REVIEW OF DETERMINATION ASSESSMENT REPORT

Application Number:	REV2021/0009
----------------------------	--------------

Responsible Officer:	Jordan Davies
Land to be developed (Address):	Lot 81 DP 4889, 27 Alan Avenue SEAFORTH NSW 2092
Proposed Development:	Review of Determination of Application DA2019/1447 for demolition works, Torrens Title subdivision of 1 lot into 2 lots and construction of a dwelling house and swimming pool and fencing on each lot
Zoning:	Manly LEP2013 - Land zoned R2 Low Density Residential
Development Permissible:	Yes
Existing Use Rights:	No
Consent Authority:	Northern Beaches Council
Delegation Level:	DDP
Land and Environment Court Action:	Yes
Owner:	Lucy Therese Giuliano Darren Sean O'Hanlon Ra El Khouri
Applicant:	Darren Sean O'Hanlon

Figure 1 - Section plan showing area of three storey building.

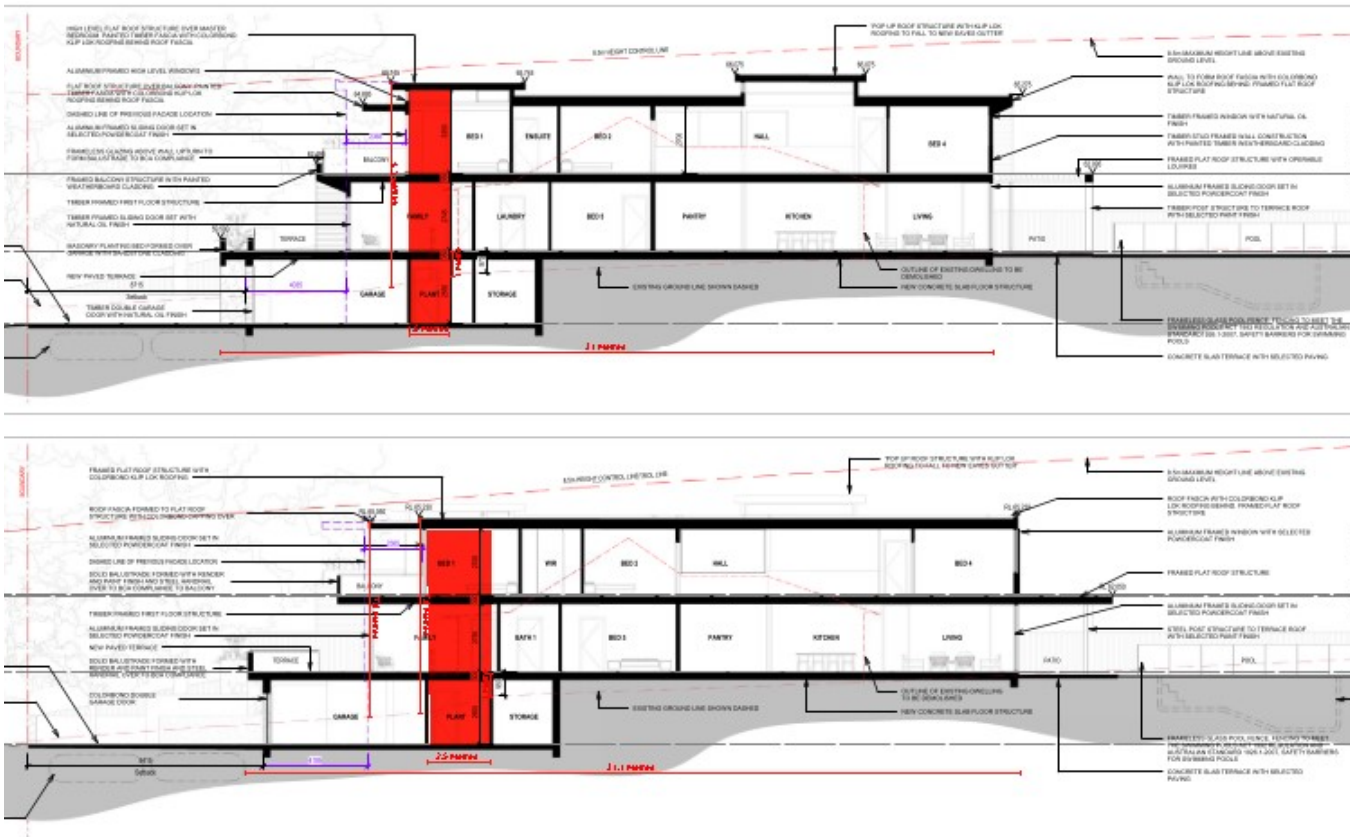
The DCP requires that buildings are a maximum of 2 stories. The proposed development is majority 2 stories, however the following portions of the development are 3 stories as described below and in the below figure:

- 27 Alan 1.6m length of building footprint, or 5% of the building footprint.
- 27A Alan 2.5m length of the building footprint, or 8% of the building footprint.

Figure 3 - 27A Alan western elevation showing area of wall height non-compliance.

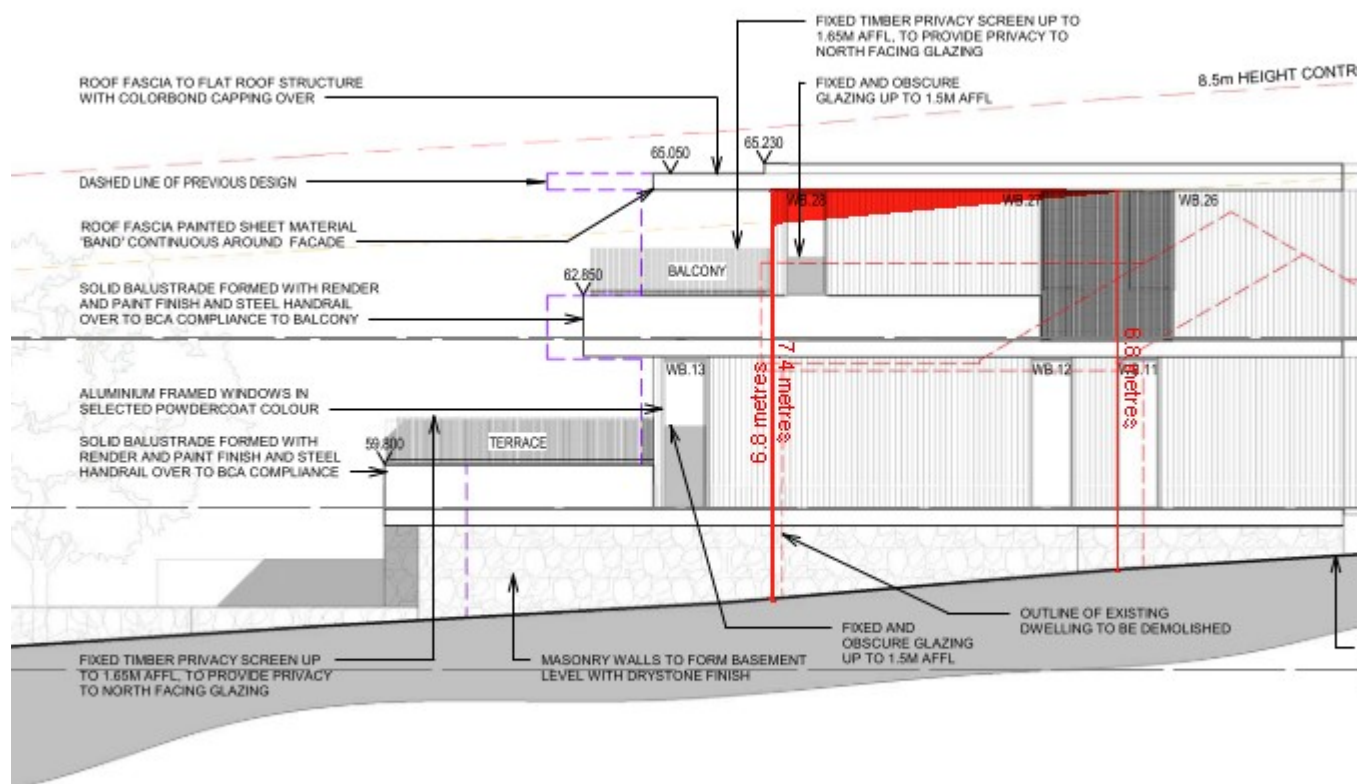
The DCP requires that the building have a maximum wall height based on the height on gradient of the land. In the case of the subject site, the average gradient across the building footprint is 1:20 and therefore the maximum wall height is 6.8m. The development has a wall height of between 6.5m and 7.4m, with the non-compliance shown in the below figures. The non-compliance is a point encroachment, with the majority of the building compliant with wall height.
